Request for Class II Permissive Change(C2PC)

FCC ID: VG8XM025FXX-Y

Please be notified that we, the undersigned, **Guangdong Midea Kitchen Appliances Manufacturing Co.,Ltd.** declare that the reasons for this class II permissive change are as below:

1. Changed Mother -board as below.

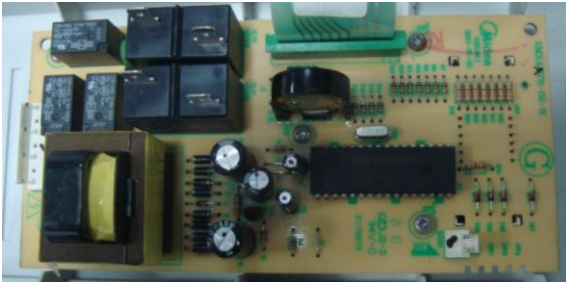
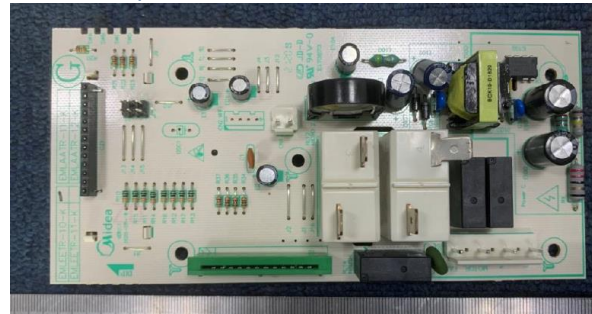
The original top /Bottom view

The new top /Bottom view

The new mother board is a switching power supply instead of the original linear transformer scheme. They have the same input, output and power except for PCB layout and some electronic component differences.
